ROTAX®
AIRCRAFT ENGINES
SERVICE LETTER

**STANDARDIZATION OF
THE CRANKSHAFT/PISTON PIN AND OF THE GEARBOX
FOR ROTAX® ENGINE TYPE 912/914 (SERIES)**

**SL-912-002 R1
SL-914-002 R1**

Bild / Fig. 2
03225

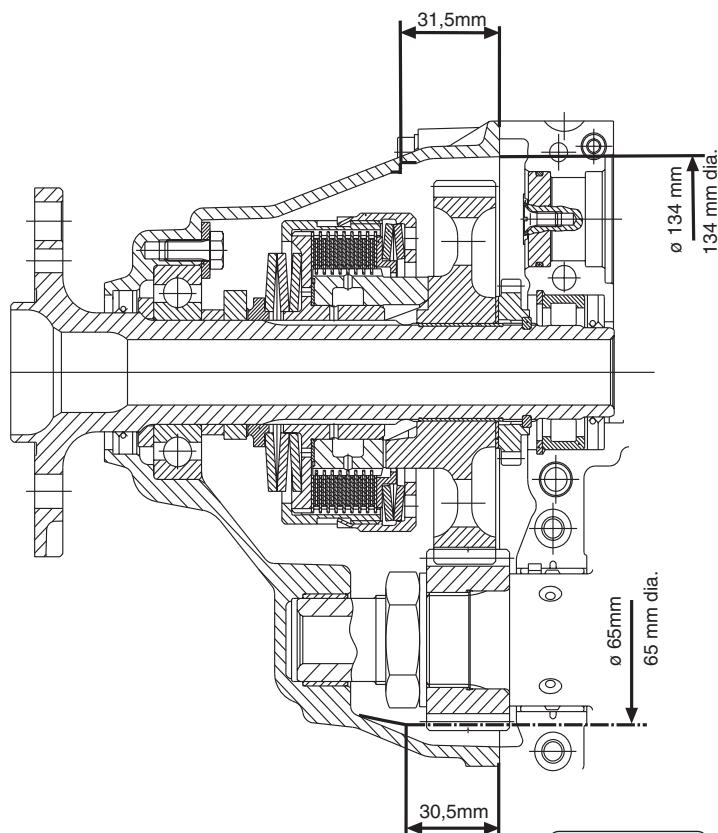
The changed axial position of the drive gear and the dog gear of increased width require extra space in the gearbox housing (see fig. 2).

■ CAUTION: The crankshaft part no. 888164 is allowed to be installed only in the gearbox housing part no. 911746, where the space between gear set and housing wall will be ensured.

Bild / Fig. 3
03047

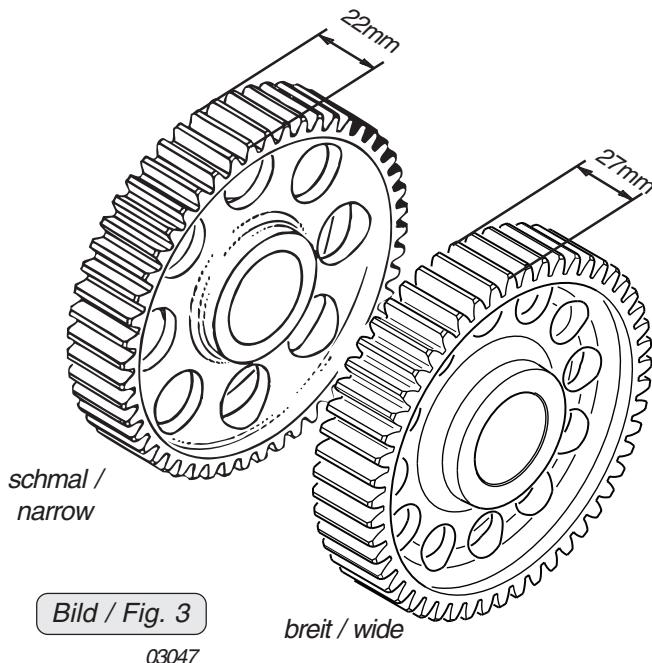
On ROTAX® 912 ULS, 912 S, 914 UL, 914 F a dog gear of a width increased by 5 mm (0,2 in) was introduced (see fig. 3). This dog gear is part of the gear set 886518.

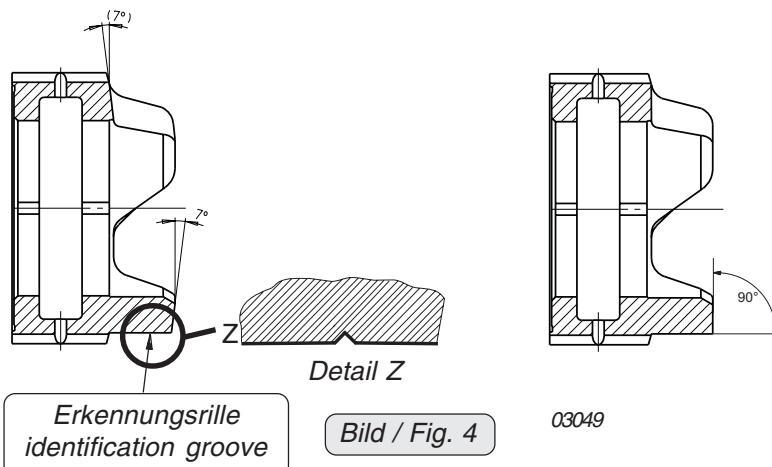
The increase in dog gear width made modification of the dog support surface necessary. The dog support surface is now machined 7° tapered (see fig. 4).

▲ WARNING: A gear set of the increased width must be only paired with the **7° tapered dog hub** part no. 958892 (without overload clutch) and is allowed to be fitted only together with the overload clutch of new design part no. 996887.

This new dog hub and new dog gear of the overload clutch must never be used in connection with a gear set of narrow width as the contact surfaces do not match correctly.

◆ NOTE: The new dog hub and dog gear of the overload clutch and the dog gear of increased width can be identified by a groove (see fig. 4).

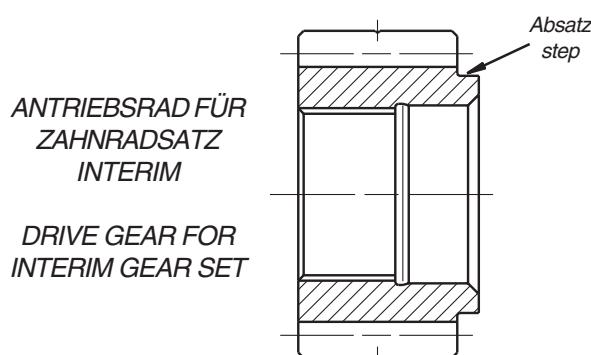
Because of the wider dog gear, it became necessary to change the axial position of the drive gear. Therefore the crankshaft part no. 888164 is furnished with a longer ending (see fig. 5).

Kurbelwelle TNr. 996583 oder älter: <1mm
Kurbelwelle TNr. 888164: 5 - 7 mm

crankshaft, part no.996583 or before: <1mm
crankshaft, part no.888164: 5 - 7 mm

Bild / Fig. 6

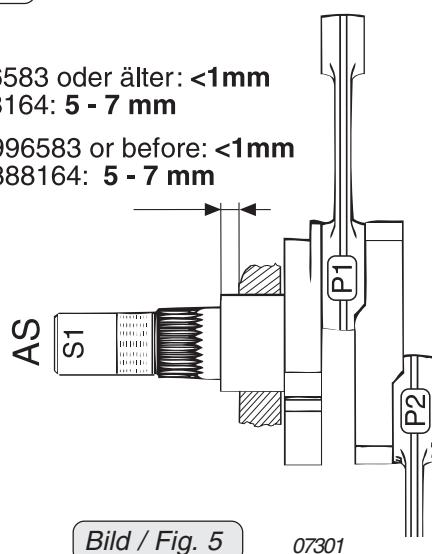
This gear set is necessary if a gearbox with a narrow gear set has to be converted into a gearbox with an increased gear set width and for a crankshaft part no. 996583 or older.

◆ NOTE: This gear set is with a drive gear of increased width which compensates for the axial staggering between crankshaft part no. 996583 and dog gear of increased width.

◆ NOTE: The interim gear set is only available with reduction ratio 2,43.

▲ WARNING: This gear set is allowed to be installed only together with a crankshaft part no. 996583 or of earlier date and in gearbox housing part no. 911746.

Bild / Fig. 7

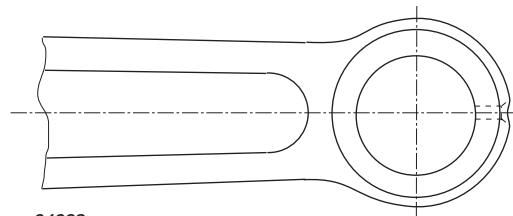
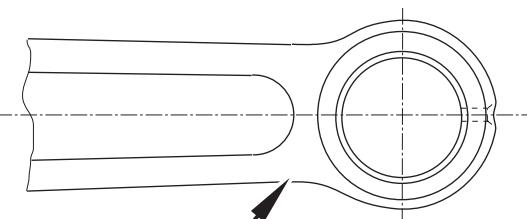
With the introduction of the crankshaft part no 888164 (see chapter. 3.1.2) the top (small) connecting rod eye was equipped with bearing socket, to be improved coupling of material with piston pin.

▲ WARNING: At the crankshaft part no. 888164 must only be used the piston pin part no. 916356. (see fig. 7-10)

All these engines the piston pin part no. 916356 can be install without considering the serial number.

Bild / Fig. 10

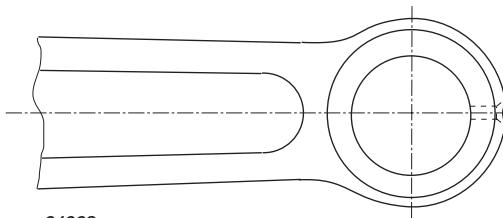
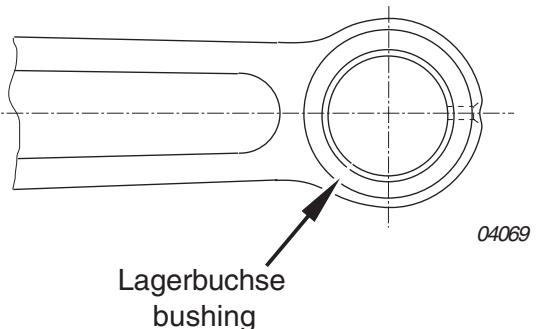
- In using of the crankshaft part no. **996583 without conrod bushing** (engines previous „group A“), there must be only 4 nitride piston pin part no. 916420 (black surface) installed. (see fig. 10)
- In using of the crankshaft part no. **996583 with conrod bushing** there must be only 4 piston pin part no. 916356 installed.
- In using of the crankshaft part no. **888164** (engines previous „group A“) there must be only 4 piston pin part no. 916356 installed.
